TYPE: TR/technical required T/technical E/editorial COMMENT STATUS: D/dispatched A/accepted R/rejected SORT ORDER: Clause, Page, Line, Subclause RESPONSE STATUS: O/open W/written C/closed U/unsatisfied Z/withdrawn

P802.3ah	02.3ah Draft 1.0 Comments				
Cl 24 Daines, Ke	SC 24.2.3.2	P 12 World Wide Pa	L10 ckets	# 3	C/ 24 Daines, Kev	SC Figure 2	24-8 P13 World Wide

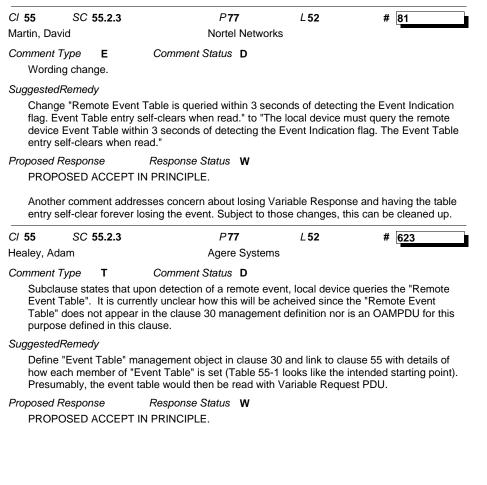
C/ 55 SC 55.2.3 P77 L40 # 6	82 C/ 55 SC 55.2.3 P77 L40 # 338
Ueda, Iori Matsushita Communic	Brown, Benjamin AMCC
Comment Type T Comment Status D The procedure of local event sending/receiving is not clear. Add the processing procedure performed while the local event continues.	Comment Type T Comment Status D Bullet a) What is the Event Table? I don't see this defined anywhere in the clause. SuggestedRemedy
Add the processing procedure performed when a local event is cleared. Also add the flow chart.	Add a description of the Event Table.
SuggestedRemedy	Proposed Response Response Status W PROPOSED ACCEPT IN PRINCIPLE.
Proposed Response Response Status W PROPOSED ACCEPT IN PRINCIPLE.	The Event Table, being first proposed in New Orleans, needs lots of work.
Will have OAM STF consider flow chart.	C/ 55 SC 55.2.3 P77 L 4054 # 26 Veerayah, Kumaran ICR
CI 55 SC 55.2.3 P77 L 40 # 1 Squire, Matt Hatteras Networks	84 Comment Type TR Comment Status D With the self-cleared event table, there are few limitations:

Comment Type T Comment Status D We say "Event Indication flag bit is sent." If there is no PDU, this cannot happer part of a frame. I think this step is unnecessary, and instead when we transmit a set the bit to 0/1 based upon whether the Event Table is empty. SuggestedRemedy Remove the line saying "Event Indication flag bit is set." Then, on page 74 line 5 the meaning of Event indication in the table to 1 = Event table is not empty	a PDU we or how many events are in the event table SuggestedRemedy Since the event table already has timestamp as an entity in each entry, retrieval of events can be based on it. The local device maintains a timestamp for its last event. The remote device on the other hand maintains a record of timestamps corresponding to the devices.
0 = Event table is not empty 0 = Event table is empty Proposed Response Response Status W PROPOSED ACCEPT IN PRINCIPLE.	Upon receipt of event notification, remote device can query the last timestamp, followed by retrieval of all events occured (or registered) between the 2 timestamps (remote's and local's). With this, there is no need for self-clearance of event table, and loss of event information is minimized. Retrieval of information for the same event will not be an issue too.
